South Texas Project Electric Generating Station P.O. Box 289 Wadsworth, Texas 77483

September 7, 2010
U7-C-STP-NRC-100199

South Texas Project
Units 3 and 4
Docket No. PROJ0772
Responses to Request for Additional Information

Reference: Letter from Tekia Govan to Mark McBurnett, "Request for Additional Information Re: South Texas Project Nuclear Operating Company Topical Report (TR) WCAP-17116-P Revision 0, Supplement 5 – Application to the Advanced Boiling Water Reactor" (TAC No. RG0012), June 7, 2010 (ML101580249)

Figure 2-1 – PCT for Different Feedwater Coast Down Times

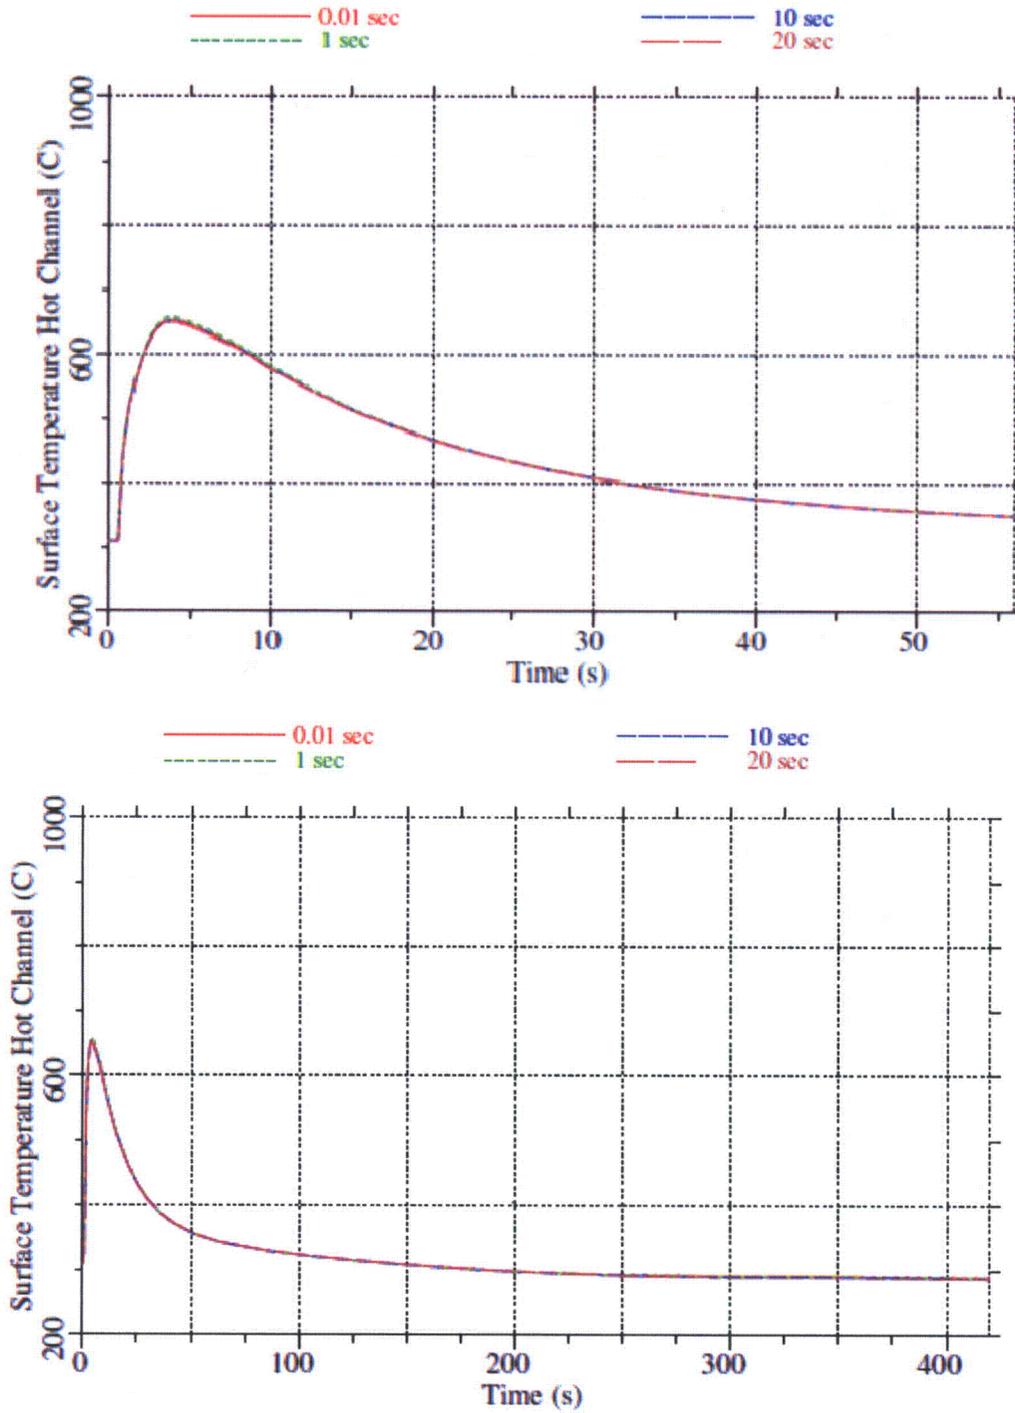
In Section 4.4.2 of WCAP-17116, fast steam line isolation is stated to be a conservative assumption because it reduces voiding in the core at the start of accident. Would this apply to feedwater as well, noting that figures-of-merit such as PCT in ABWR appear to be a function of very early formation and collapse of voids in the reactor coolant rather than long-term coolant inventory makeup? Demonstrate that the assumption of fast (1 s) feedwater coast down is conservative from the standpoint of PCT.

To investigate the effect of feedwater coastdown time on the calculated Peak Clad Temperature (PCT), additional GOBLIN runs were performed with feedwater coastdown times of 0.01, 10 and 20 seconds. These calculations showed no difference in the calculated PCT for hot or average channels when varying the assumed feedwater coastdown time. Because the PCT occurs so early in the accident sequence, continued flow from feedwater pumps is unlikely to have a significant effect on the PCT. Figure 2-1, below, shows clad temperature for the limiting elevation of the hot channel as a function of feedwater coastdown time. Note that the curves for the four coastdown times are superimposed on top of each other.

These calculations conclude that feedwater coastdown times that are longer than the fast (1s) coast down time do not have an effect on the PCT.

Figure 3-1 Variation of Maximum Cladding Temperature During Partial Core Uncovery with Respect to Bundle Peaking Factor

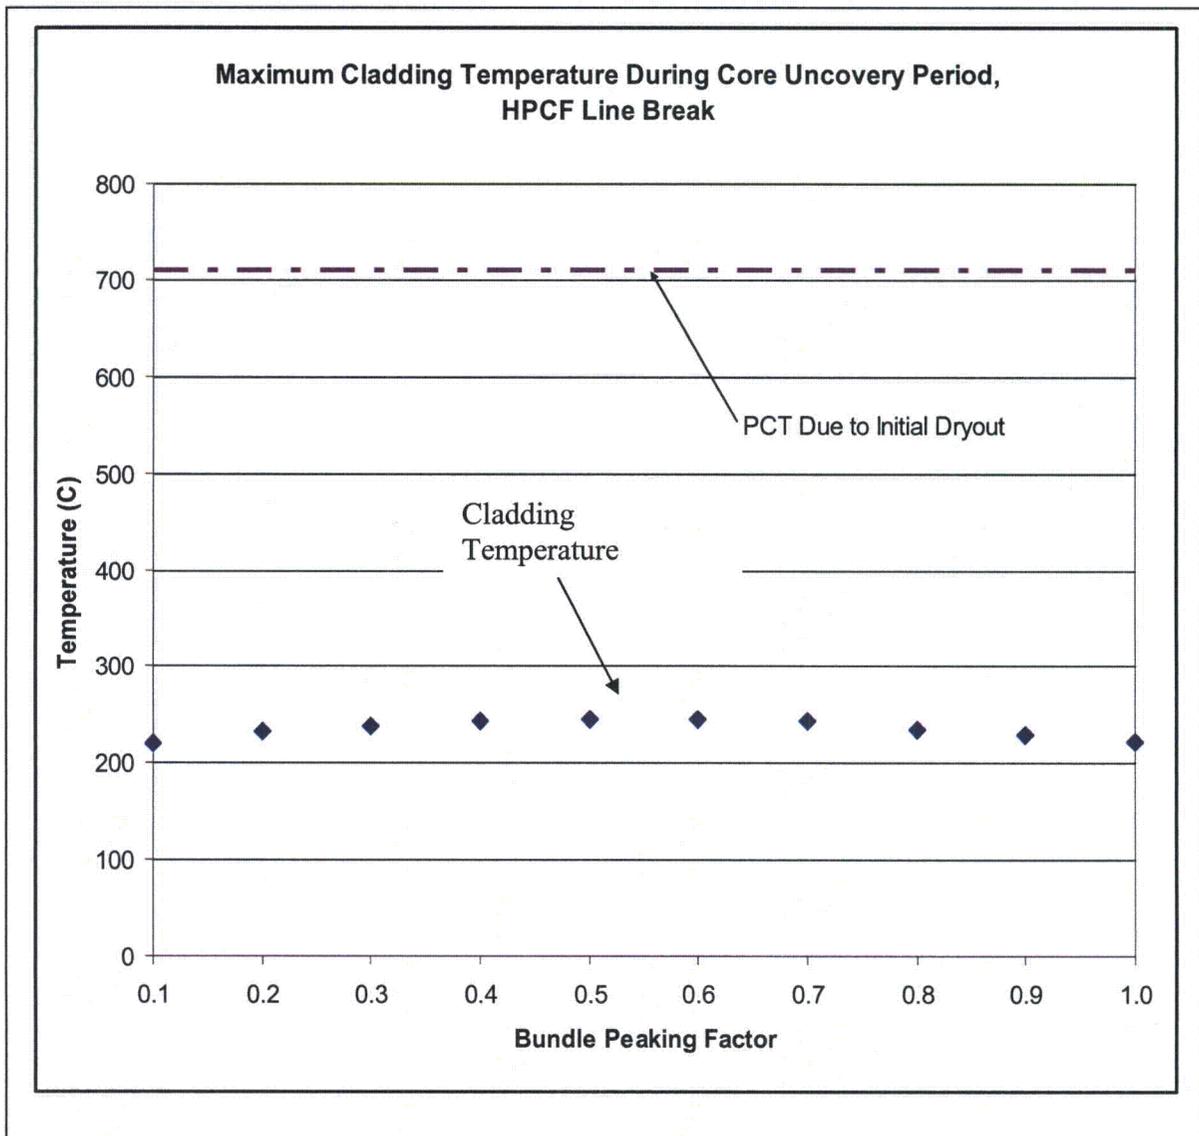
Section 4.5.1.2 of WCAP-17116 (HPCF break spectrum sensitivity cases) describes how prediction of core uncover is more likely in low-power assemblies than in high-power ones due to swelling of the two-phase mixture. In view of this, it is not intuitively obvious a priori which channel would be the most conservative one to consider (highest-power, lowest-power, or somewhere in between).

- a) Can you demonstrate that no assembly would experience PCT significantly higher than the ones documented in the sensitivity analysis (i.e., would explicit modeling of an intermediate lower-power assembly yield more conservative results)?
- b) What is the procedure for the identification of hottest channel?

- a) The bundle power peaking factor values for the High Pressure Core Flooder (HPCF) break bundle power sensitivity study of 0.3, 0.6, 0.9, 1.2, 1.5 and 1.7 are expanded to cover peaking factors ranging from 0.1 to 1.7, and a peaking factor resolution of 0.1 is used.

For each power level, the GOBLIN maximum cladding temperature during the core partial uncover period after the automatic depressurization system (ADS) is actuated, is shown in Figure 3-1. The GOBLIN peak cladding temperature (PCT) due to the initial dryout is also included for comparison purposes.

The results of the expanded study, as shown in Figure 3-1, show that the maximum cladding temperature during the partial uncover is well below the PCT during the initial early dryout time, and the maximum cladding temperature is also a well behaved function of bundle power. Figure 3-1 also shows that the maximum cladding temperatures for these additional assumed bundle peaking factors are not significantly higher than the ones documented in the sensitivity analysis in WCAP-17116-P. Therefore, explicit modeling of lower power assemblies is not warranted.

- b) Because the maximum cladding temperature during the partial core uncover is well below the PCT that occurs during the initial dryout due to the pump coastdown, the hottest channel is the one with the channel power described in Section 4.3.1.2 of WCAP-17116-P.

Figure 11-1 Break area for the RIP failure

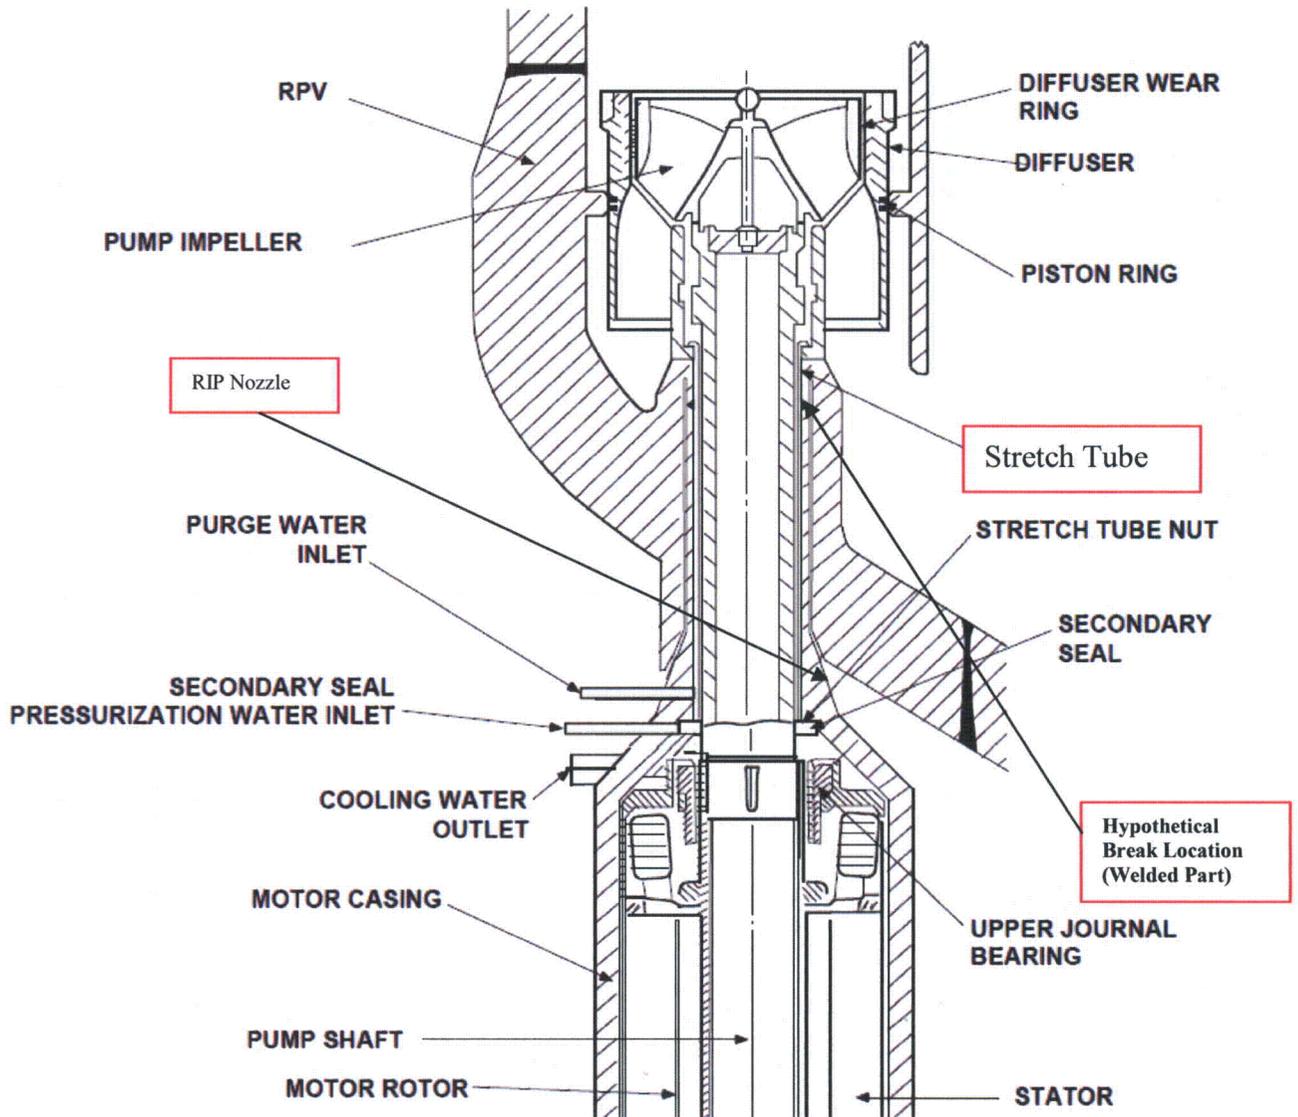
a) Discuss the transient response to a RIP failure LOCA.

OR

b) Provide justification to support the ABWR DCD assumption that the break flow due to the RIP failure would be bounded by the break flow in BDLB accident scenario. What is the equivalent break flow area for the RIP failure?

A detailed justification, which supports the assumption that the break flow due to Reactor Internal Pump (RIP) failure is bounded by the design basis Bottom Drain Line Break (BDLB), is provided in ABWR DCD Tier 2 Subsection 15B.3.4.

The break area for the RIP failure, which is equivalent to a gap between the stretch tube and the RIP nozzle (See Figure 11-1), is less than the design basis BDLB area (20 cm²).

Figure 16-1 Integrated Heat Transfer from Steam Dome Structures to Coolant for FWLB3 case

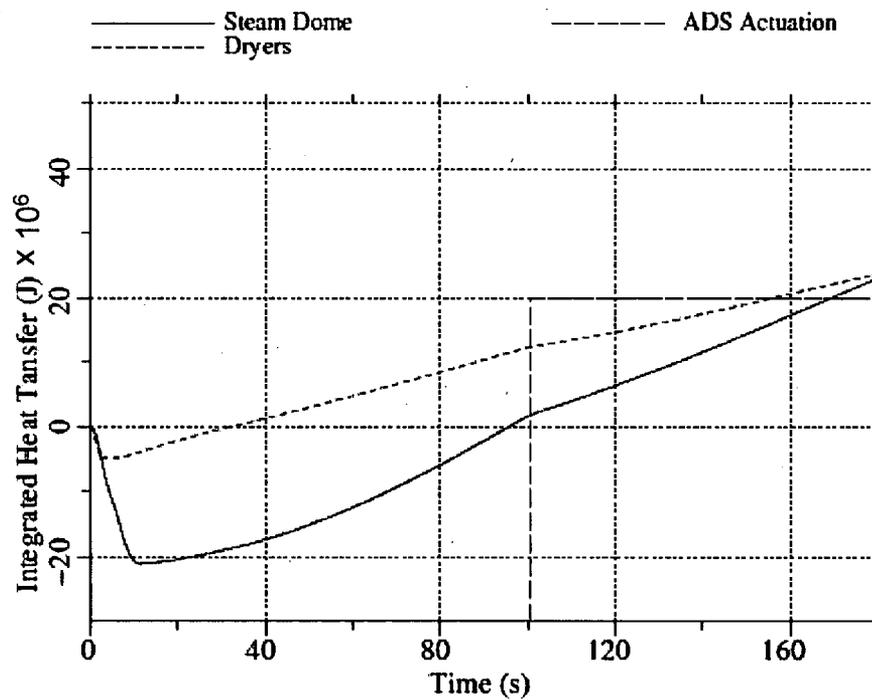
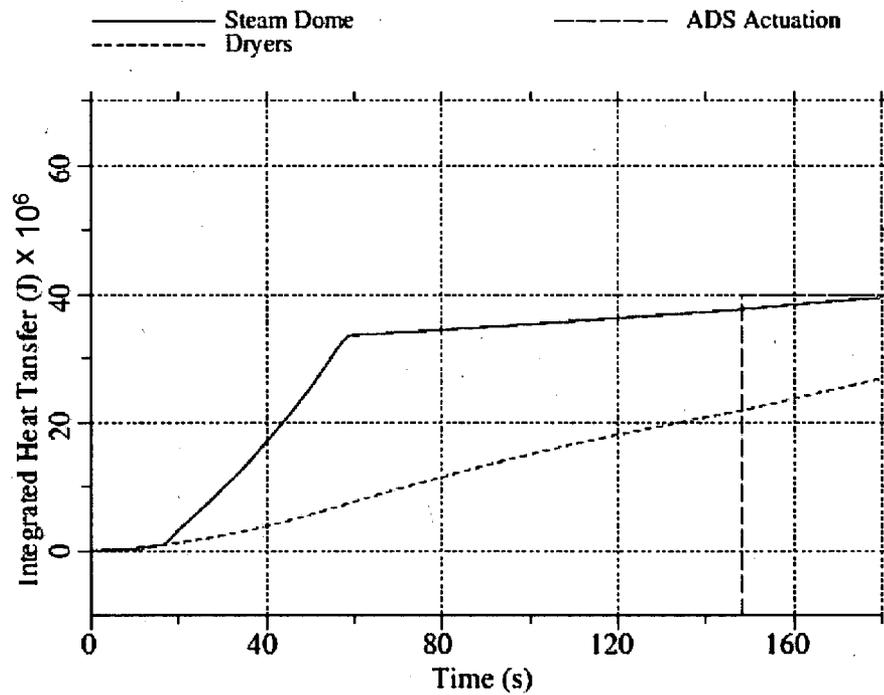
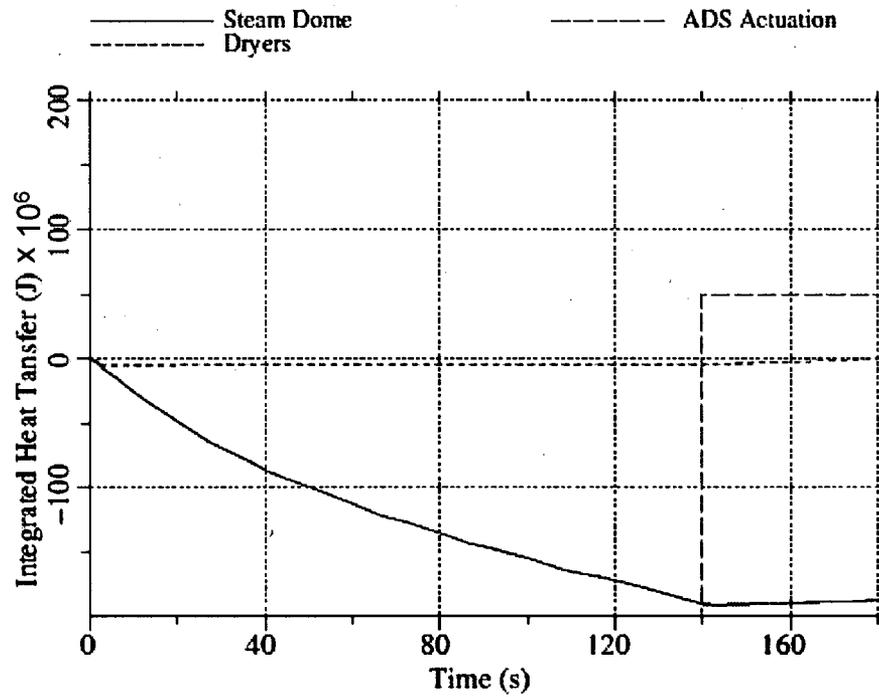
- a) Since the steam dome volume acts as a dead volume prior to ADS actuation, metal heat release to steam could increase the steam enthalpy above saturation. When ADS activates, the rate of system depressurization could be affected by the amount of energy removal. Describe the metal heat release to the dead volume and estimate the amount of heat released to steam prior to ADS actuation and the potential for superheated steam to be vented through the ADS.
- b) Is the volume and metal heat of the piping to the point where it is isolated from the reactor coolant system accounted in the ABWR ECCS Evaluation Model?

- a) Table 16-1 shows the heat transfer between the metal of the steam dome and the steam immediately before the Automatic Depressurization System (ADS) actuates for each of three breaks. Figures 16-1 through 16-3 include the same data, along with the time when the ADS valves open. The steam flowing to the ADS valves becomes superheated in all cases described below except for the feedwater line break.

The ADS most affects the high pressure core flooders (HPCF) line break (HPCF3) transient because the system recovery is delayed until the low pressure core flooders (LPFL) pumps start. In this case, note in Table 16-1 that the heat transferred to the coolant in the steam dome is in the negative direction (from the steam to the metal) prior to ADS actuation. The initial temperature of the structures in the steam dome is based on normal operating conditions. After the break occurs, the steam line is isolated by fast closure of the turbine control valves. This results in a pressurization of the system, and the system pressure is controlled by the opening and closing of the safety / relief valves (SRVs). Because the steam dome pressure is higher than the initial operating pressure during this time, the steam temperature will be higher than the temperature of the metal structures. As a result, heat is transferred from the steam in the steam dome to the structures (e.g., the vessel dome and the steam dryer) as shown in Figure 16-3. After ADS actuates, the system pressure (and temperature) decreases and the direction of heat transfer reverses.
